Access Compliance Report

Public Rights-of-Way

Intersection ID: 28003	Main Street: COMMUNITY_HOUSE_RD	Cross Street: WILLOW_ROCK_DR	Location: SE
ADA ID: 4FEB0BBF3F7A	Ramp Type: BlendTrans2	Initial Pass/Fail: Pass	Overall Compliance: No
Severity Score: 0			
Codes/Mitigation Info/Possible Solution		Field Measurements/Component Compliance

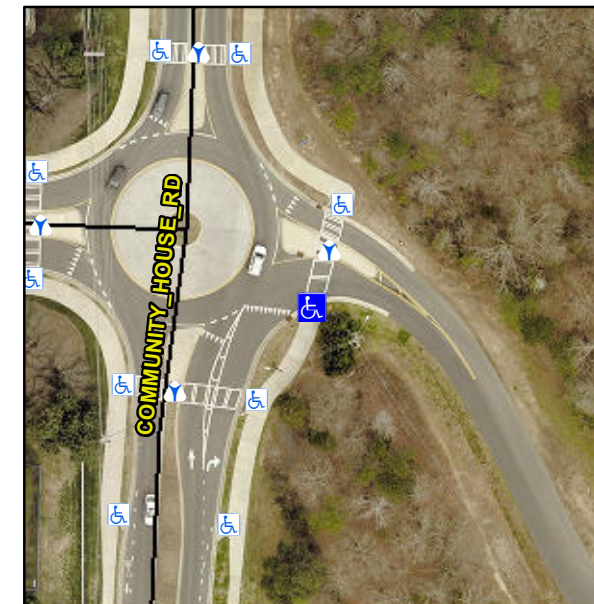
Not Found, R304.5.3

X Walk 1 X Slope (%)	0.0		X Walk 2 X Slope (%)	N/A
Yes	Ramp inside XWalk1?	Yes	N/A	Ramp inside XWalk2?	N/A
	Road Slope (%)	0.0		Clear Space?	Yes
	Road X Slope (%)	2.0	N/A	Clear Space to XWalk (in)	N/A
Yes	Any Obstructions?	No	Yes	Storm Grate/Utility Hazard?	No
	Obstruction Type			Storm Grate/Utility Type	
		N/A			N/A
			Yes	Surface Condition? (G/P)	Good
			No	Curb Slope (%)	5.1

Remove & Replace Curb Slope and Extend Ramp. Remove & Replace Gutter.
